C. Randy Hutchinson
Vice President
Operations ANO

2CAN119901

Subject: Arkansas Nuclear One - Unit 2
Docket No. 50-368
License Nos. NPF-6
Proposed Technical Specification Changes And Resolution of Unreviewed Safety
Question Associated With Applicable Limits And Setpoints Supporting Steam
Generator Replacement

FIGURE 3.7-1
MTC Versus Maximum High Linear Power Level
And Trip Setpoint

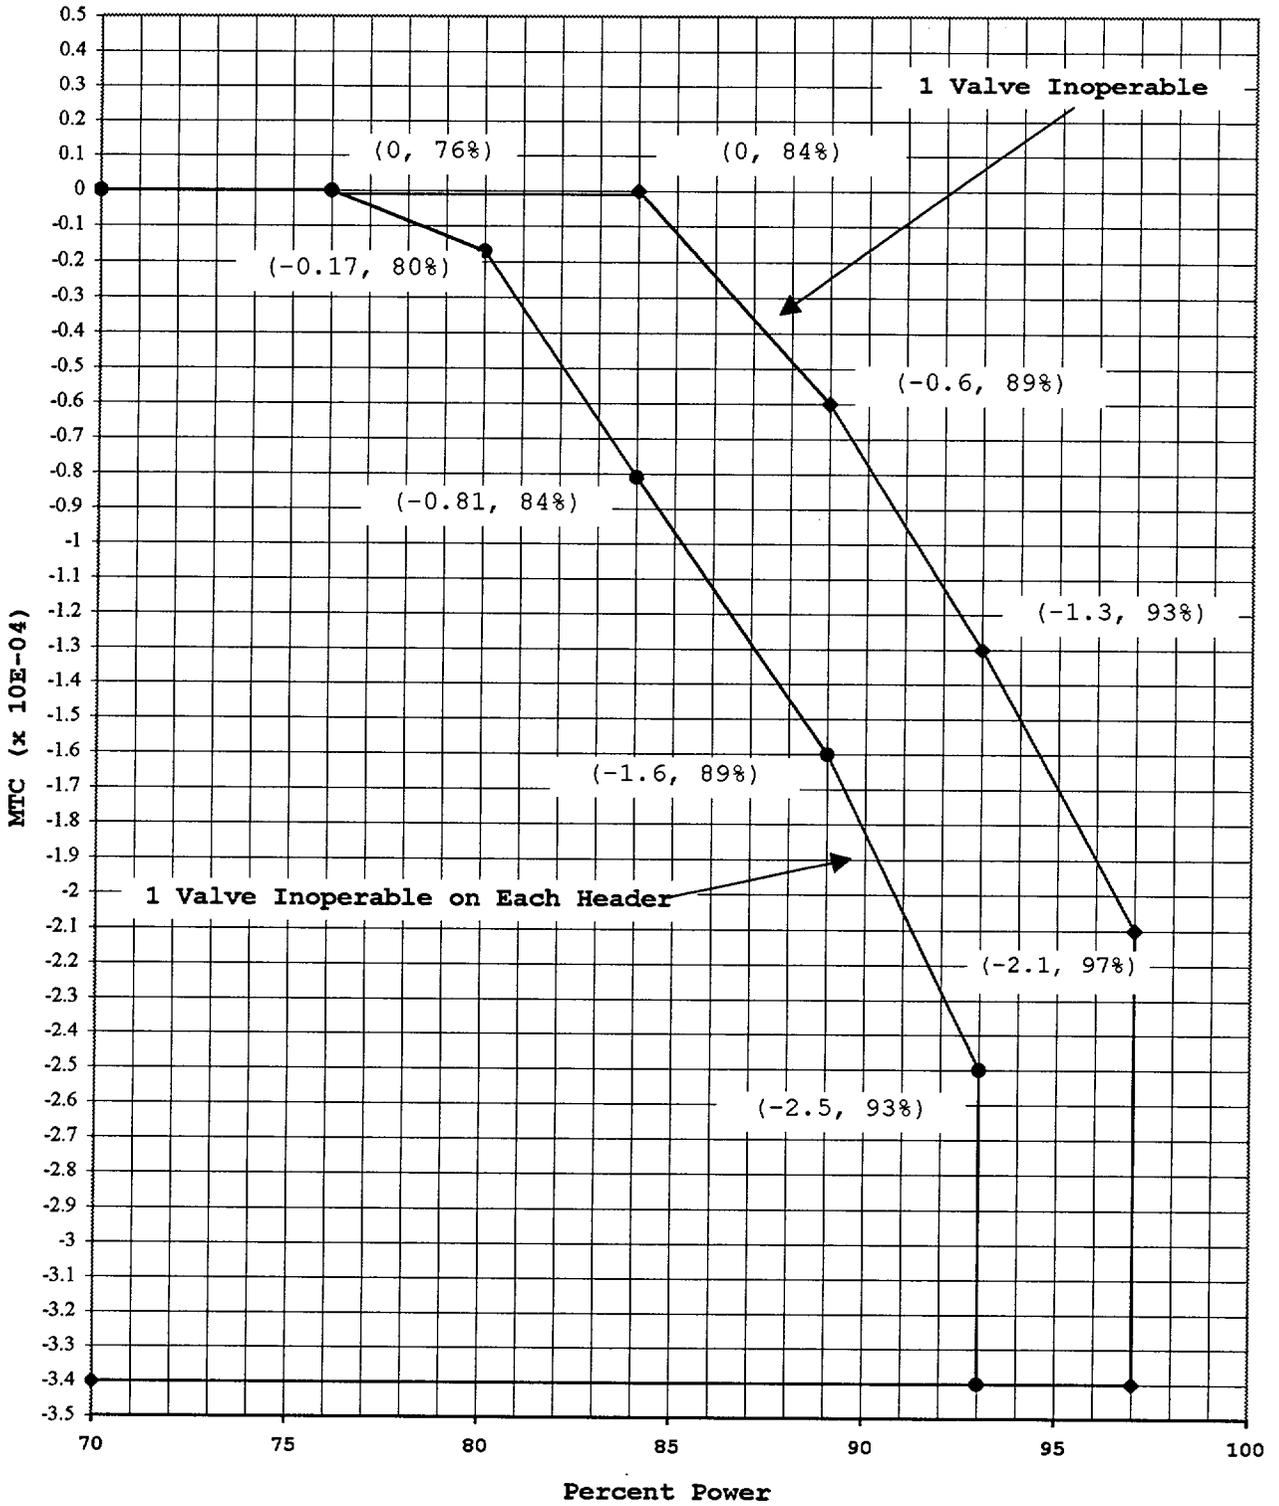
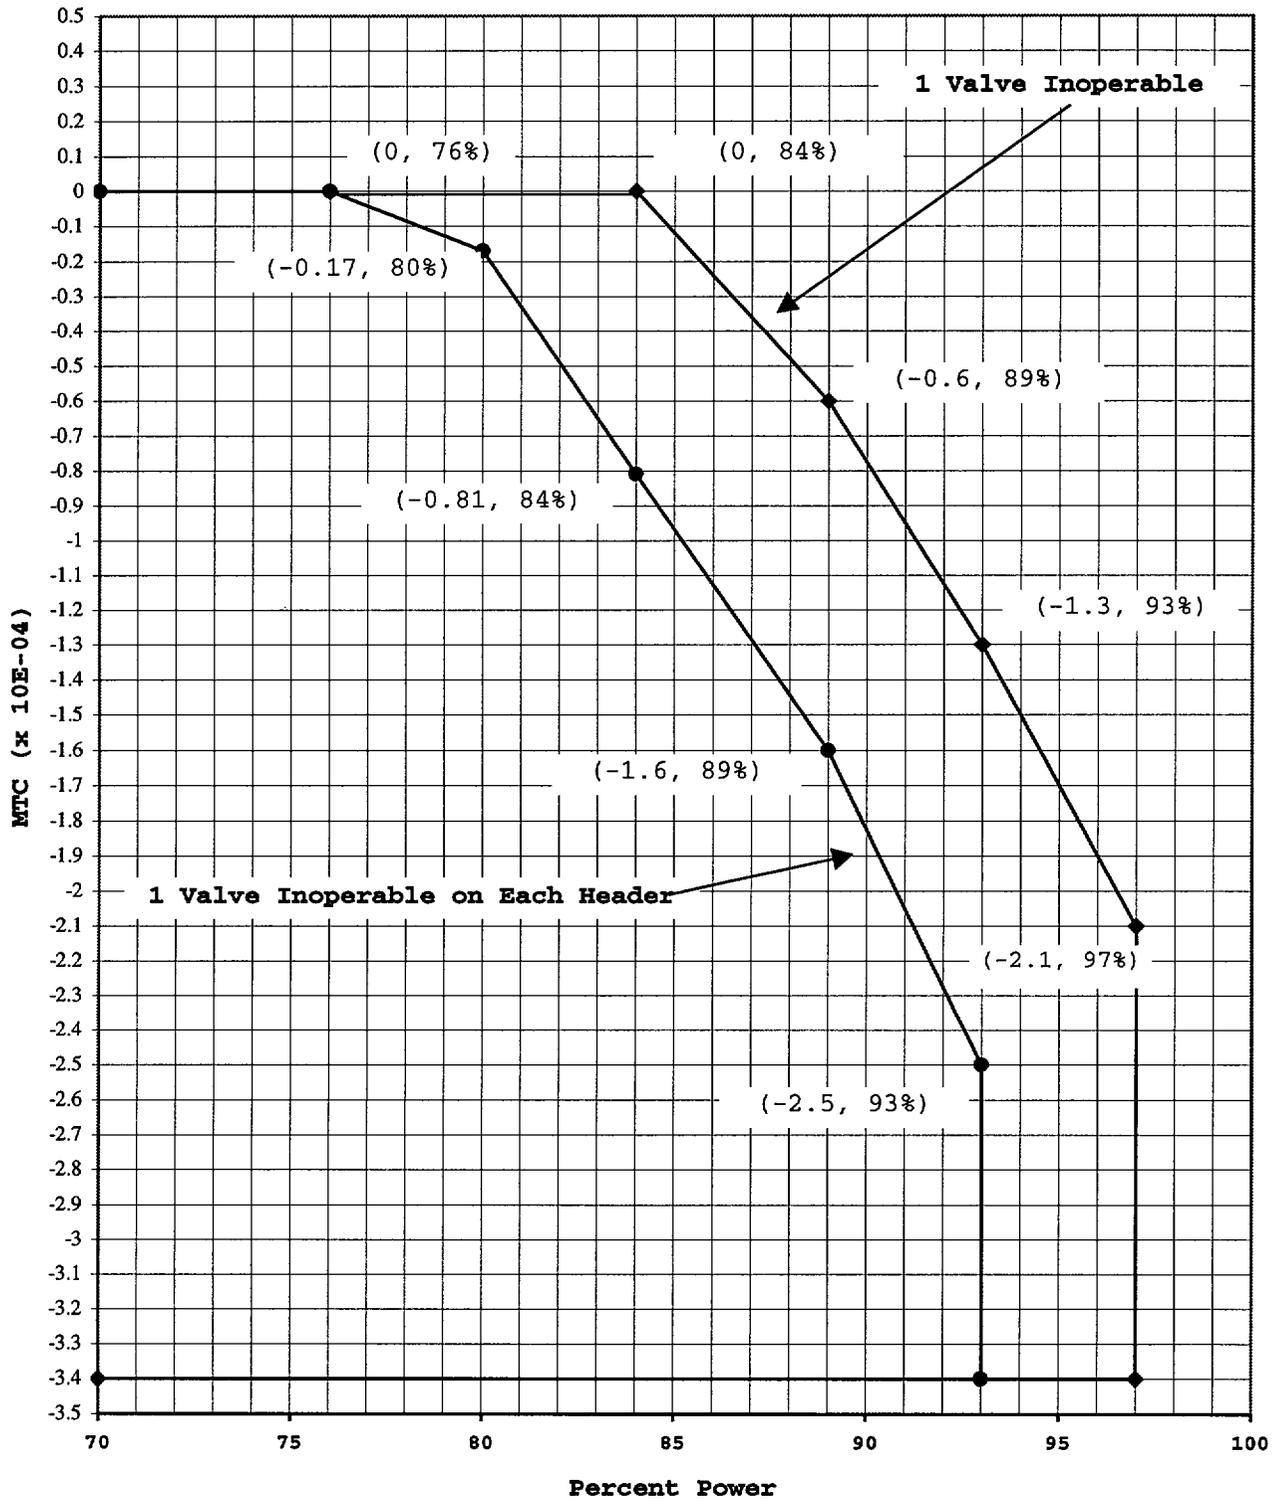
- New TS Figure 3.7-1, "MTC Versus High Linear Power Trip Setpoint," has replaced the deleted Table 3.7-2 on page 3/4 7-3 to provide a comparison of the percent of rated power versus the MTC as a method of determining the value for the Linear Power Level – High Trip setpoint during periods when a MSSV(s) is inoperable.

The addition of Figure 3.7-1 provides a graph of MTC versus the setpoint for the Linear Power Level – High Trip. The figure provides guidance for configurations with one MSSV inoperable up to a total of one MSSV per steam header being inoperable. In addition, a MTC versus EFPD correlation (Figure 1.0.2-1 of Enclosure 4) will be developed. This correlation will be incorporated into operating procedures. The user may obtain the current MTC value based on EFPD (core life) from the appropriate procedure, apply the MTC value to the proposed TS Figure 3.7-1, and acquire a High Linear Power Trip setpoint. The application of this new figure provides for a High Linear Power Trip setpoint for conditions where not more than one MSSV is inoperable on each steam header to support testing of the MSSVs without a significant decrease in plant power.

The setpoint reductions during conditions of two or more MSSVs being inoperable on each steam header are conservative with respect to the analysis performed in support of this submittal. Likewise, the application of MTC versus rated thermal power Figure 3.7-1 has been found acceptable for conditions where not more than one MSSV is inoperable per steam header. Therefore, the proposed changes associated with the High Linear Power Trip setpoints relating to cases where MSSVs are inoperable are acceptable.
